**Subject:** FW: Response to ARG's False Claims about CM Pool's Amendments to The Grove PUD  
**Attachments:** True Trips Table.pdf

**Agenda Item:** The Grove at Shoal Creek Planned Unit Development

## The Grove at Shoal Creek Planned Unit Development Parks Plan Exhibit

## The Grove PUD Erosion Assessment

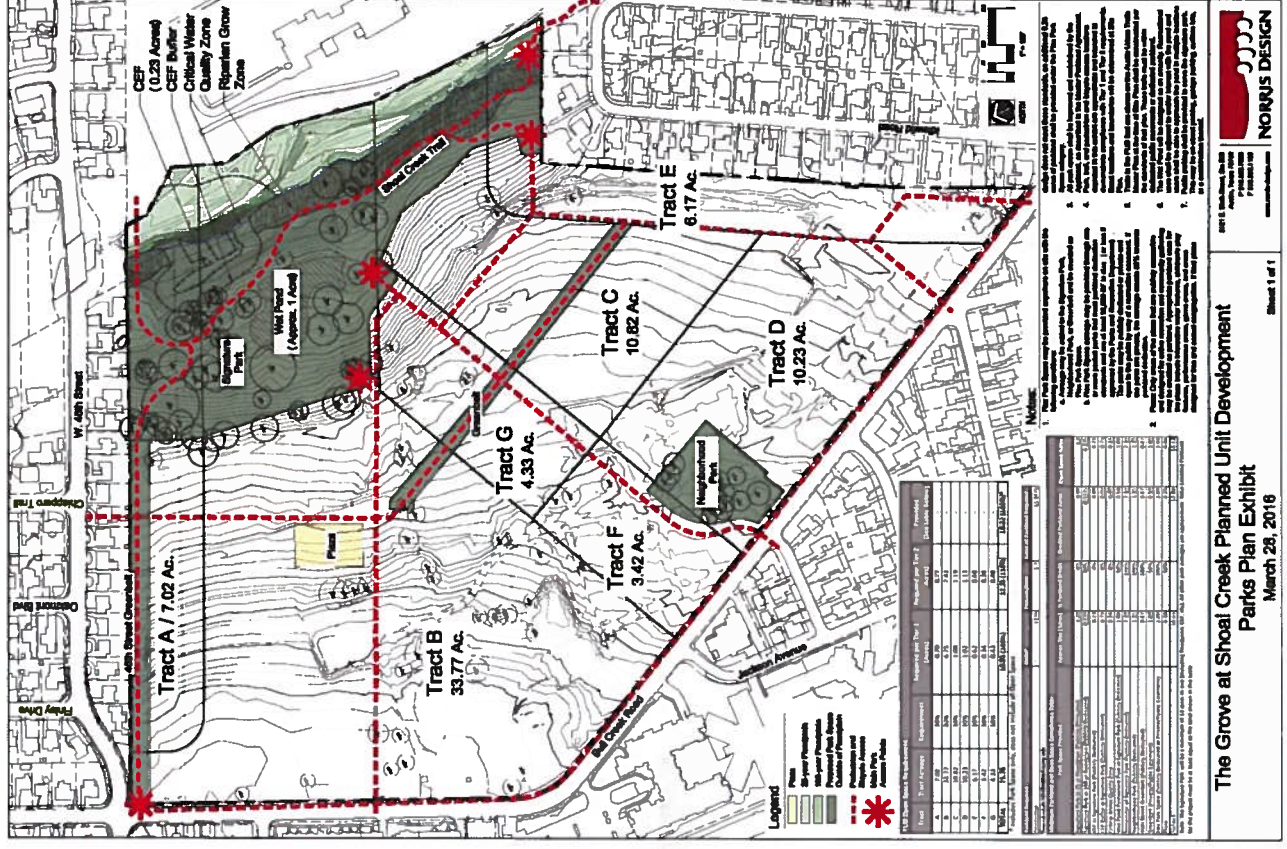
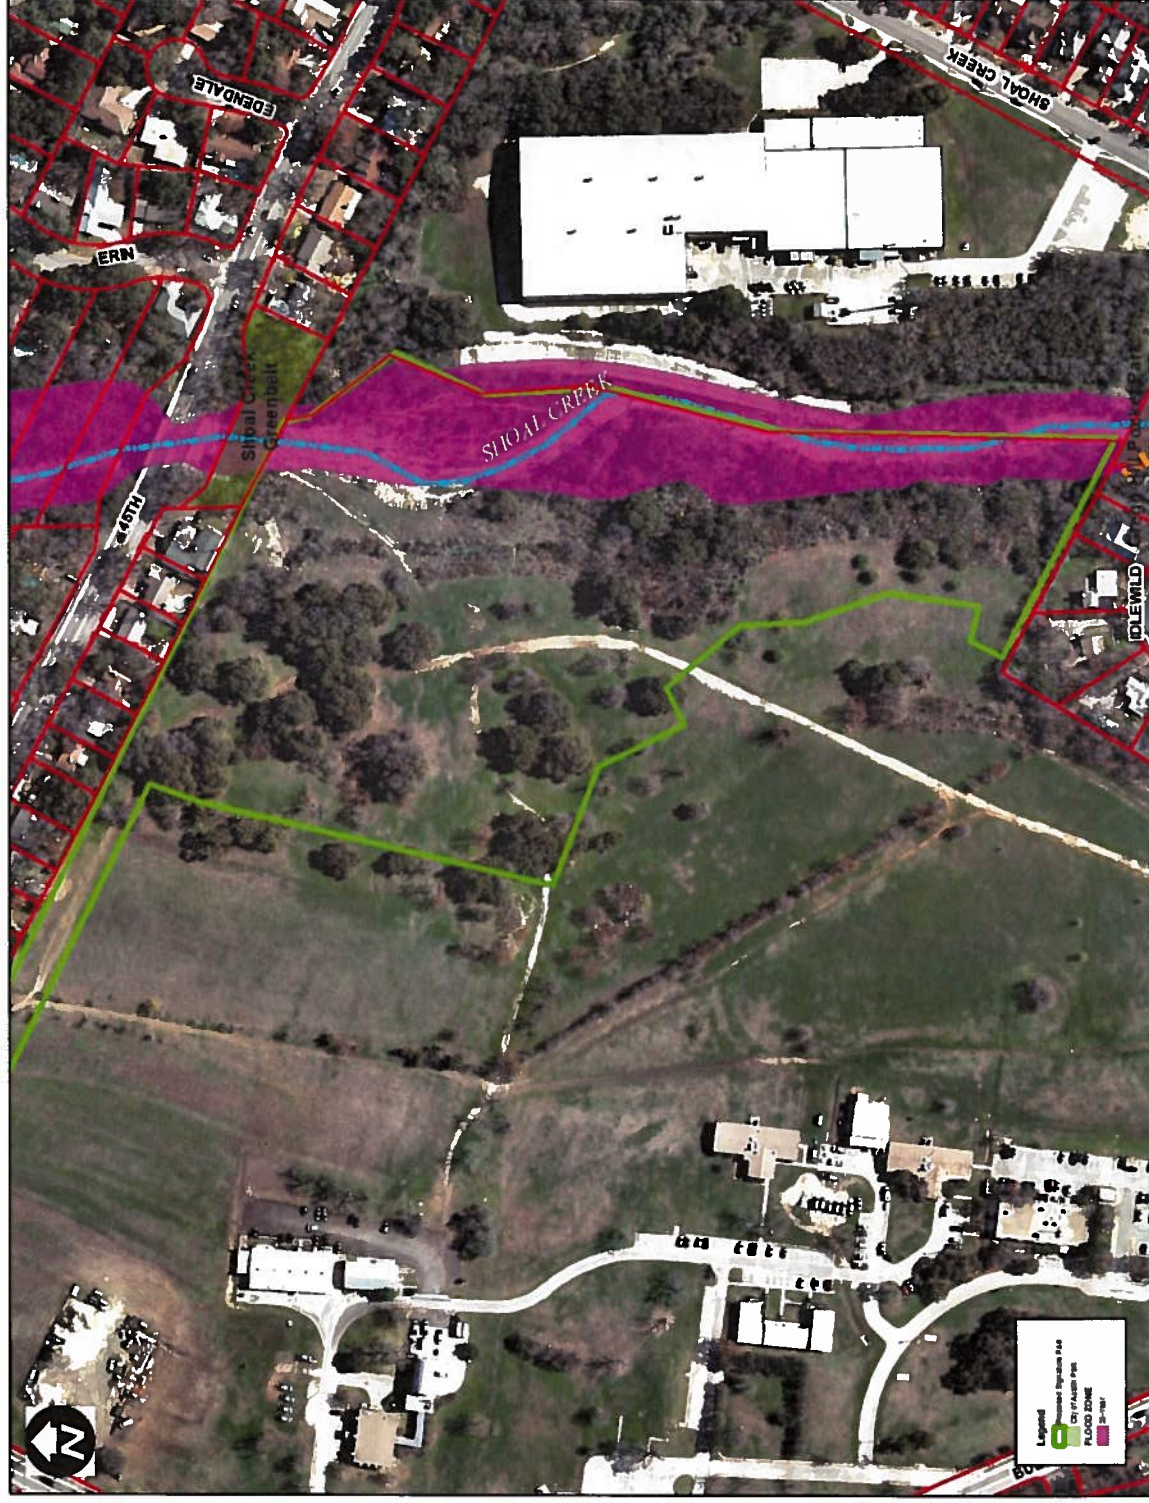
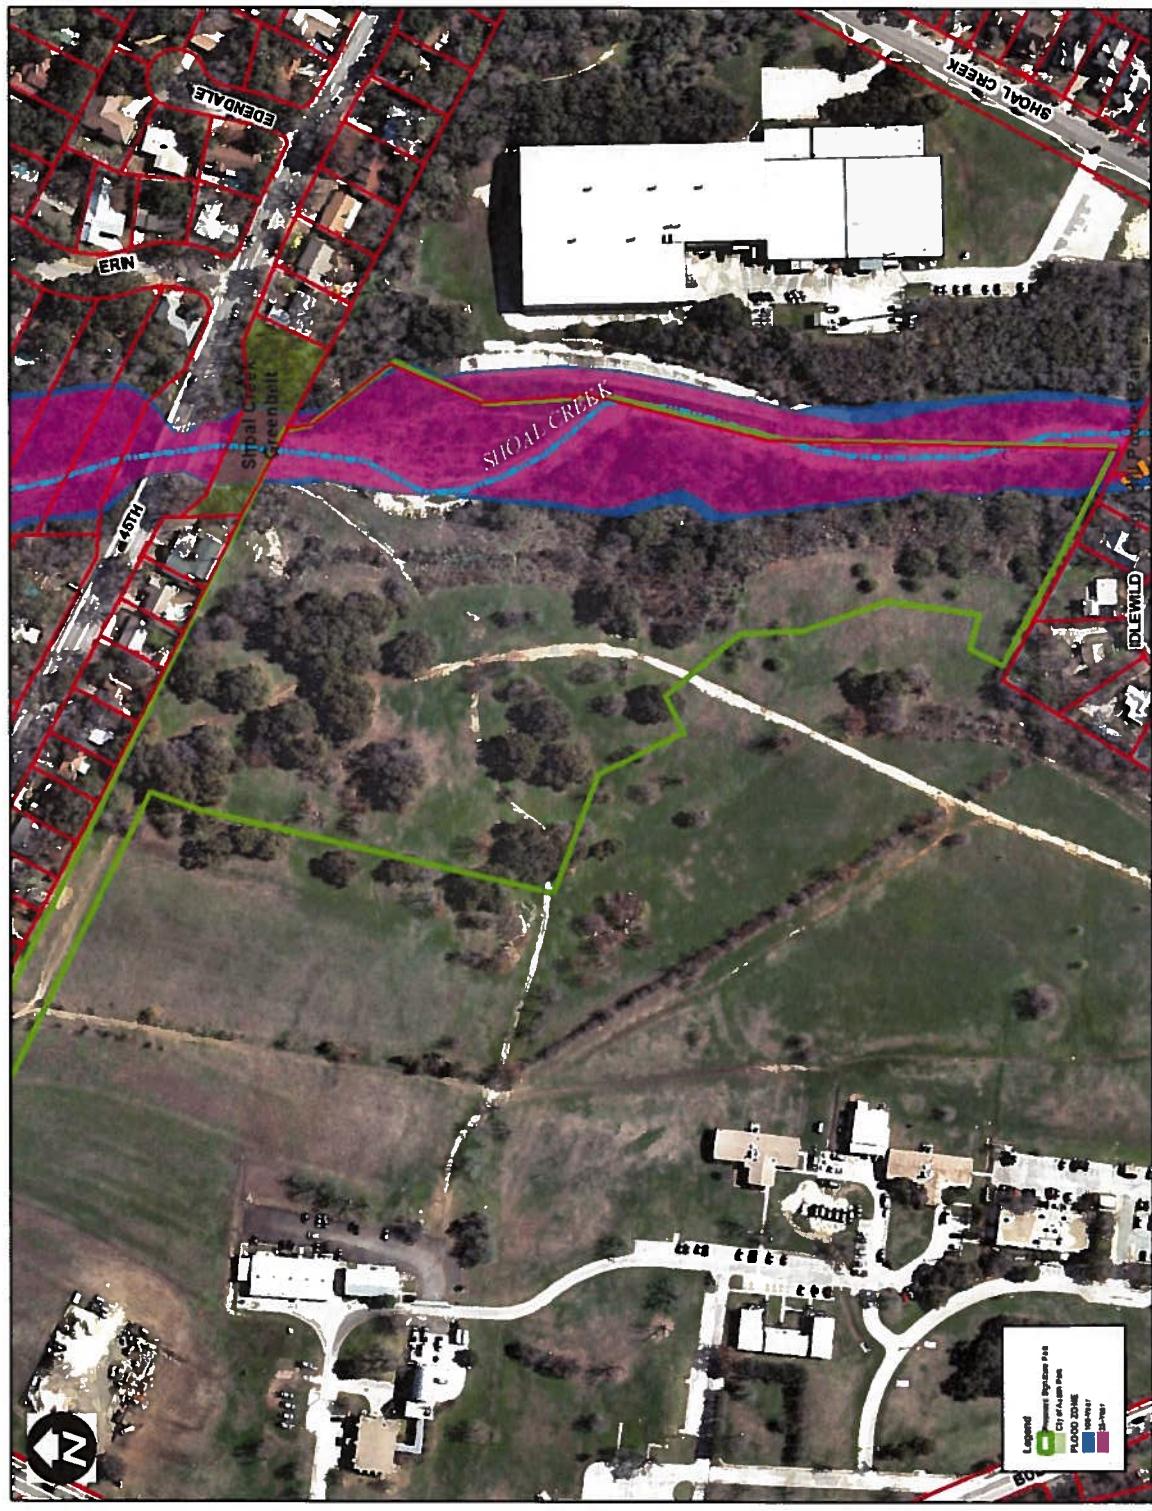
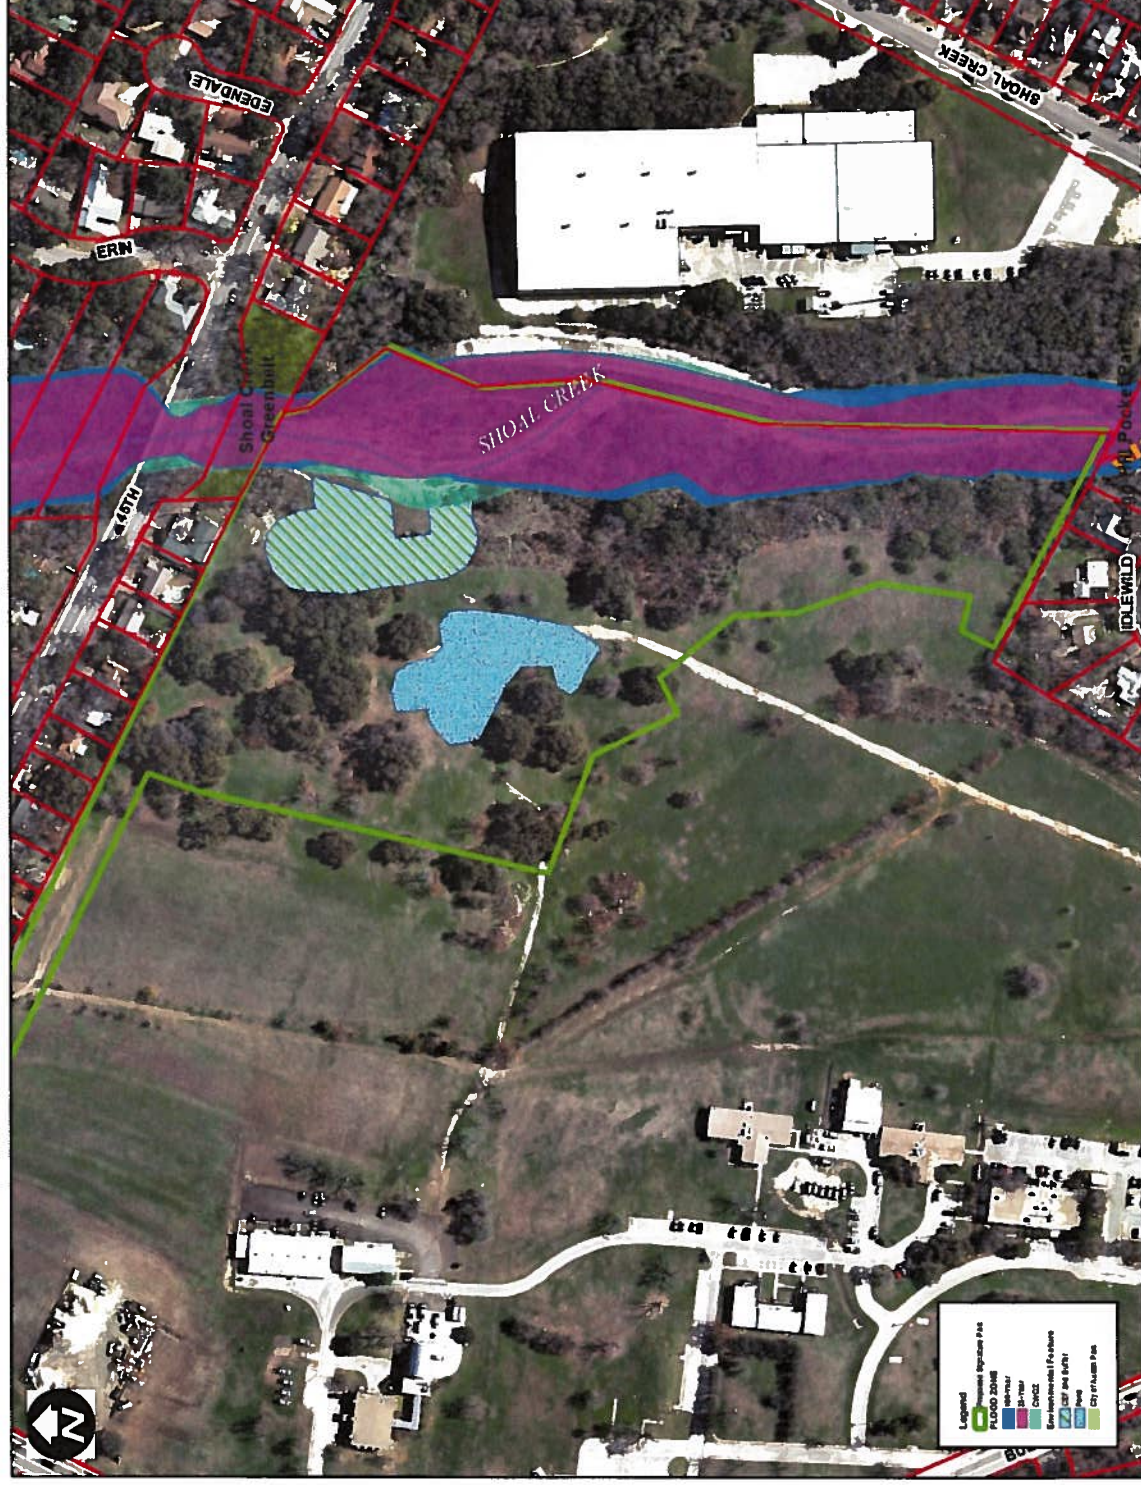
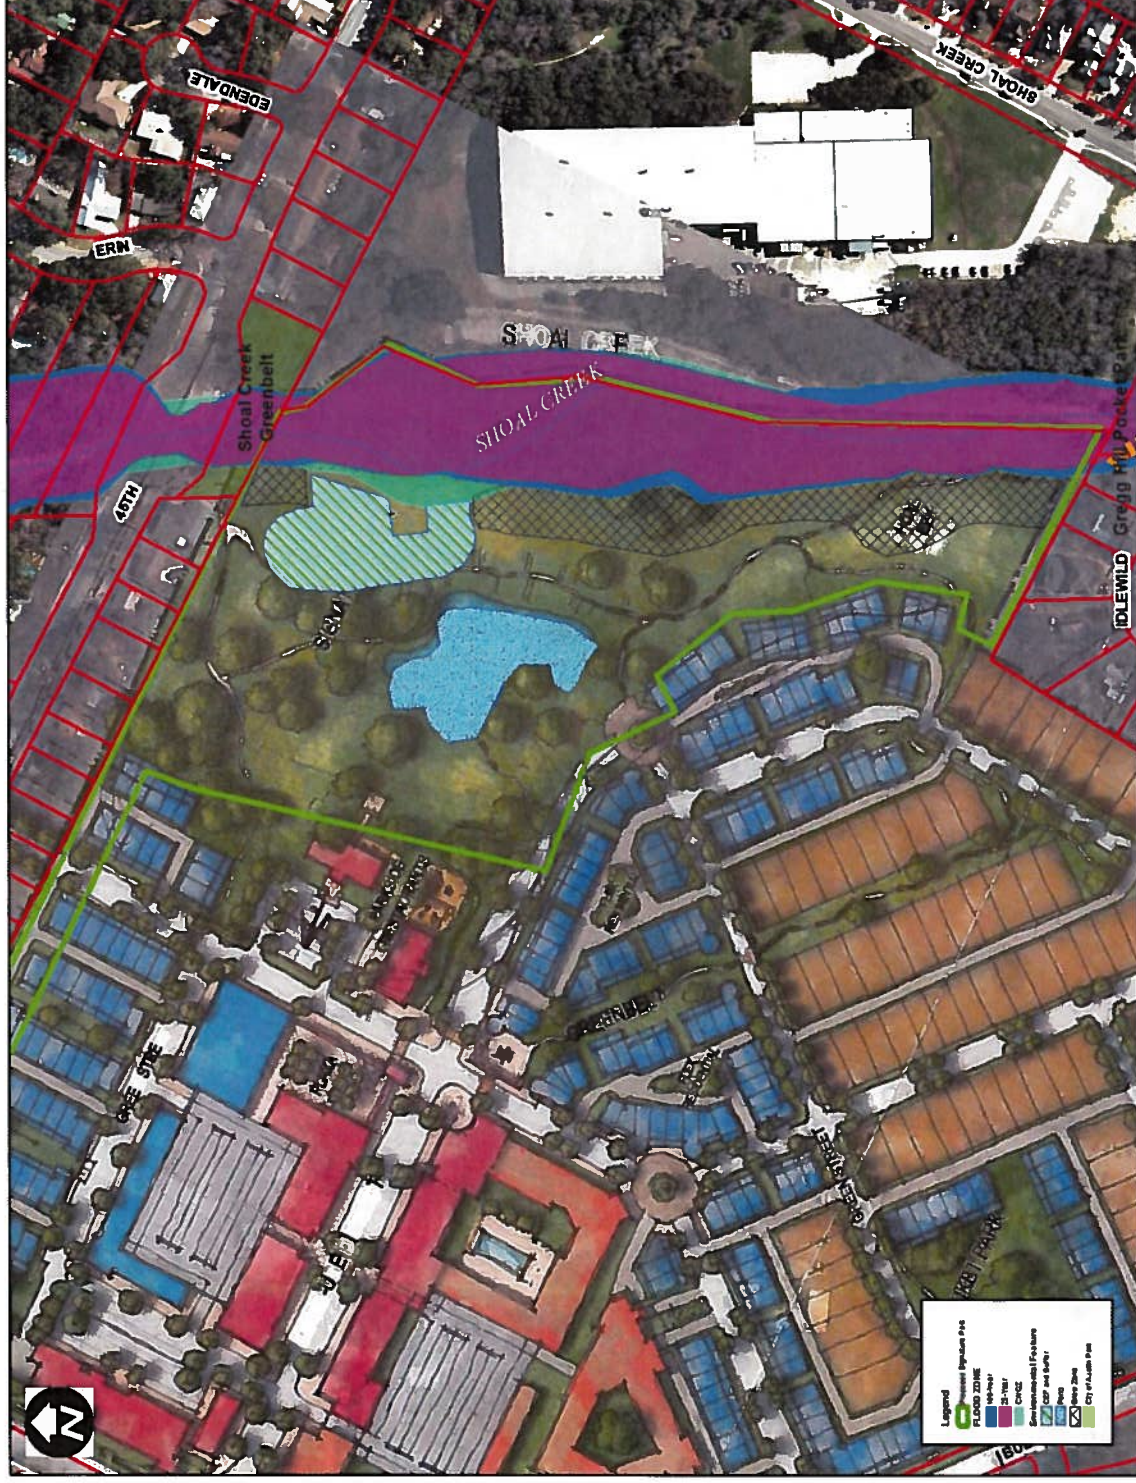
**Rationale for frontage and acreage needed to provide the frontage:**

- The development along the frontage of most of the Signature Park will hide the park amenities, much as the playscape at Central Market and the Arboreteum cow sculptures are hidden from street view at those developments today. Those are not parkland. They provide an example of how we feel the Applicant's configuration will not address the public realm.

- We need street frontage for superiority, regardless of how much acreage is owed. To this end, we would change Note 8 on the June 7, 2016 Park Exhibit that state: " the signature park should have a minimum of 400 feet of total street frontage" to " the signature park should have a minimum of 1,100 feet of total street frontage." Also see the attached graphic that extends the proposed park space outside of floodplain to show the street frontage.

**No Credit  
for 25- Year  
Floodplain  
= 10.68 Acres**

□ Acreage Credits – Signature Park (13.88 acres)

Half Credit  
for 100 -  
Year  
Floodplain  
= 10.56 Acres

No credit for  
CEF, CWQZ  
and 1/2 of  
Pond

**= 8.88 Acres**
